TM Jeans Ltd

Holding-41, Ward-22, Bahadurpur, Mirzapur, Gazipur

12 November 2024

Observation-03: Dampness in the brick wall. (Building 1: Production Building)

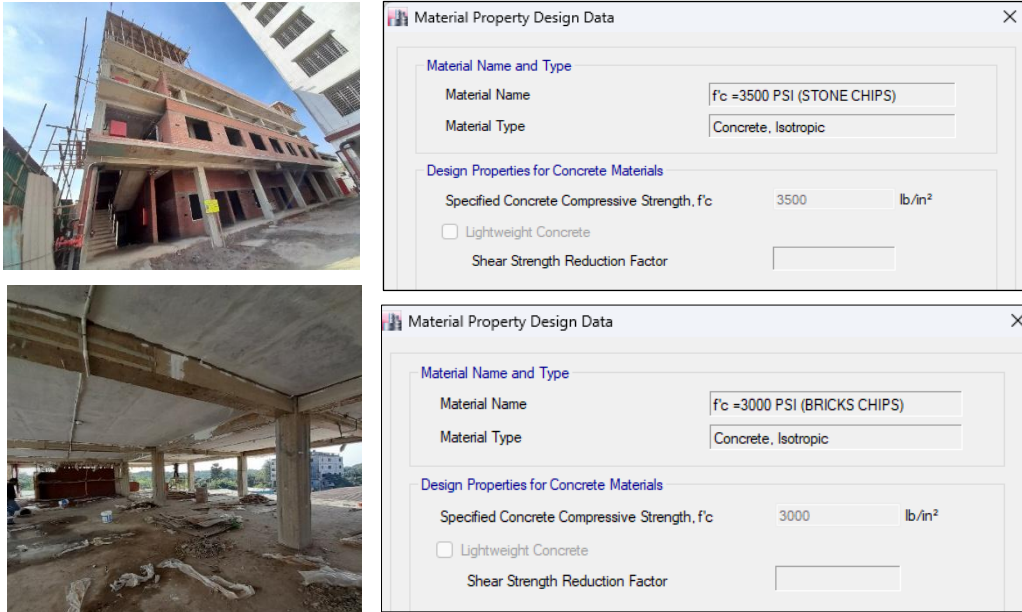
Description: During the inspection, dampness was observed on the brick wall. The building engineer is required to seal the source of water and repair the damp areas with a suitable method.

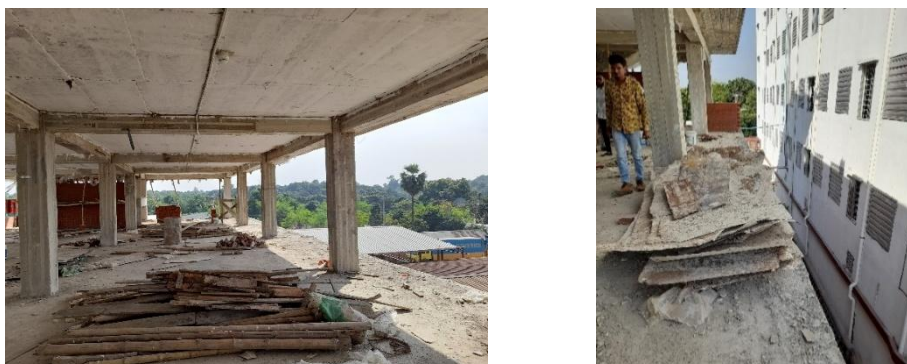
Description: During the inspection only one sets of concrete cylinder test report from footing was available for Building-2. The provided number of cylinder test reports does not meet the requirement of test frequency as per BNBC-2020: Part-6: Section 5.12.2. In FEA model 3500 psi concrete strength has been considered for the column and 3000 psi for the beam & slab.

The building engineer is required to provide the adequate number of existing cylinder strength data test reports otherwise verify the in-situ concrete strength by taking at least four numbers of concrete cores from the lower tier of columns. Also, concrete cores need to be taken from the beam and slab at least four numbers based on concrete type.

Observation-06: Falling hazard risk on 2nd floor. (Building 2: Medical, Childcare & Dining Building)

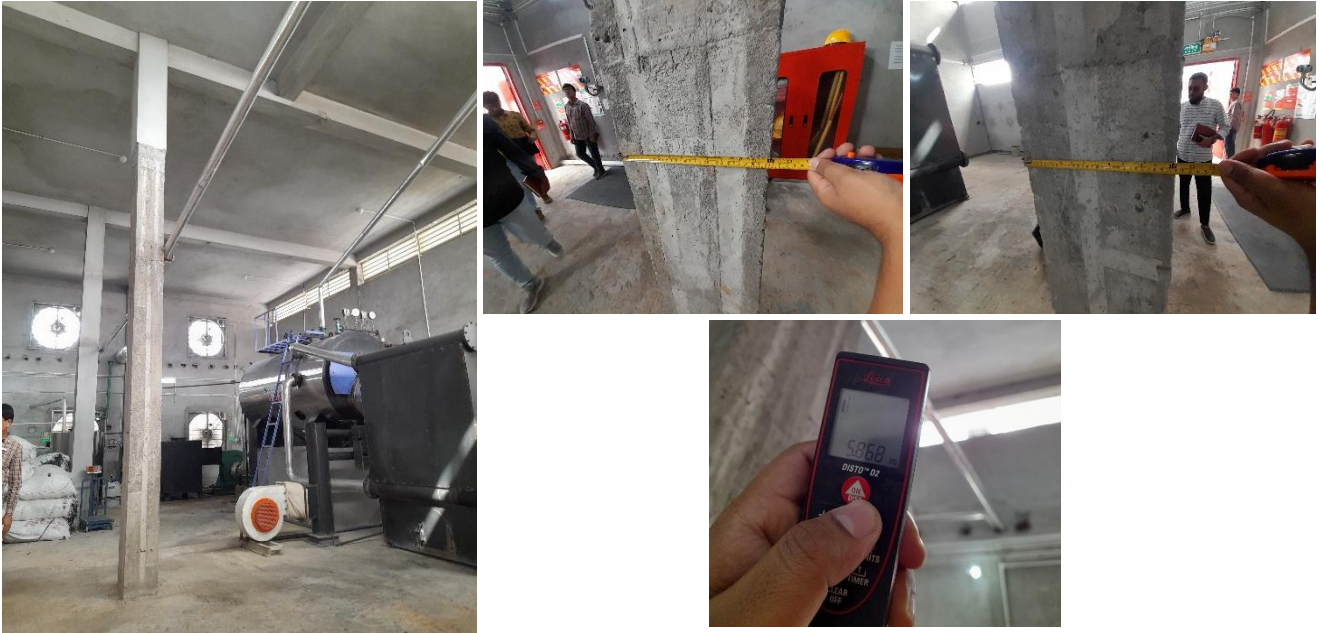
Description Railings/barriers were missing at 2nd floor level. Also the construction materials was found stored at edge of the slab that may cause serious injuries if fall down. The building engineer is required to provide railing/barrier at 2nd floor.

Observation-07: Column seems to be slender (Building 3: Utility Building)

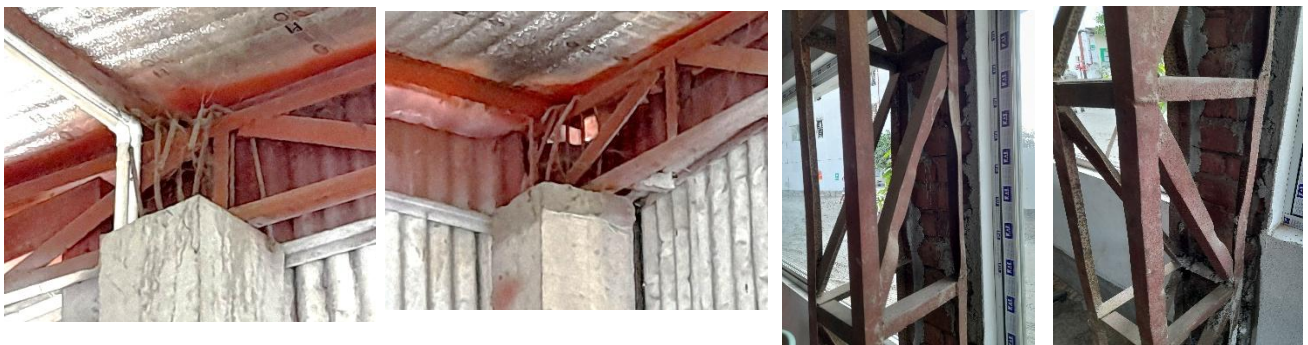
Description: Ground floor columns are 5.86 m in length and 300X300 mm in size. The $KL/r = 33.83$; indicates that the columns are slender. So, the building engineer is required to check the adequacy of the column for the slenderness.
